Staff Report

REPORT NO.: DSD-2024-106

SUBJECT: Minor Variance Application A2024-018 - 351 Blucher Blvd.

Figure 3 - Proposed Site Plan drawing

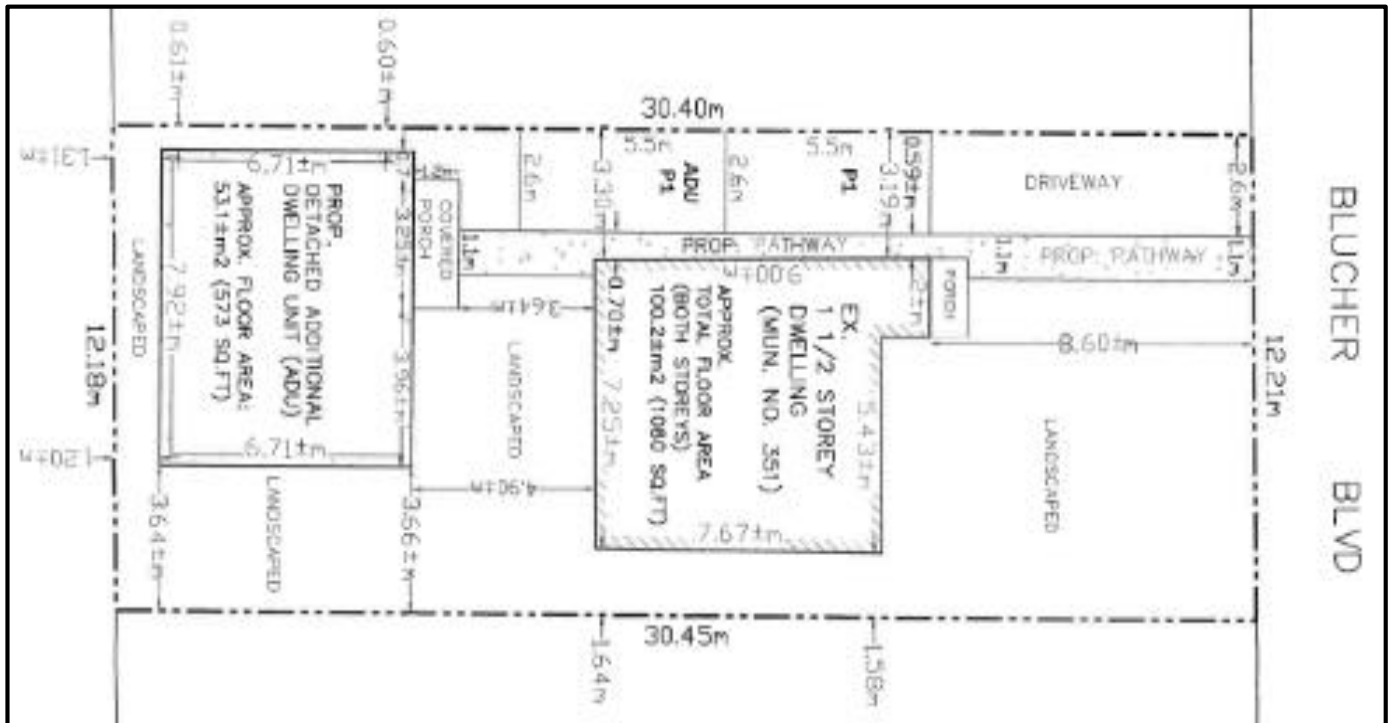
The proposed sidewalk does not accommodate the emergency walkway for fire prevention as it is shared with the parking space. Therefore, the proposed variance for the reduced walkway width does not meet the intent of the Official Plan.

Unobstructed walkway: The zoning regulation for the unobstructed walkway is to provide a clear entry pathway for unit tenants and emergency services to the ADU. The required width of an unobstructed walkway in the Zoning By-law was determined in consultation with Fire Services. The walkway can not be combined with the driveway or required parking space as it needs to be kept clear and unobstructed at all times. In this case the required walkway to the ADU is proposed to be combined with the required parking space.

Unobstructed walkway: Part of the proposed walkway is to be shared with the required parking spaces, and its width is less than the minimum required by 0.5 metres when shared with the required parking. A 0.59 metre wide unobstructed walkway is not a sufficient width to provide access to the Detached ADU and its reduced width could have detrimental impacts in the provision of fire/emergency services.

The minor variance to permit a reduced walkway width is not desirable for the appropriate development or use of the property as it could impact the provision of fire/emergency services.

to facilitate an Additional Dwelling Unit (Detached) in the rear yard of the subject property, generally in accordance with drawings prepared by Dryden & Smith Head Planning Consultants Ltd., dated January 22, 2024, with a revision to relocate the required unobstructed 1.1 metre wide walkway, **BE APPROVED.**

And that the Variance in Minor Variance Application A2024-018 requesting relief from Section 4.12.3 n) of Zoning By-law 2019-051 to permit an unobstructed walkway to have a width of 0.59 metres instead of the minimum required 1.1 metres **BE REFUSED.**
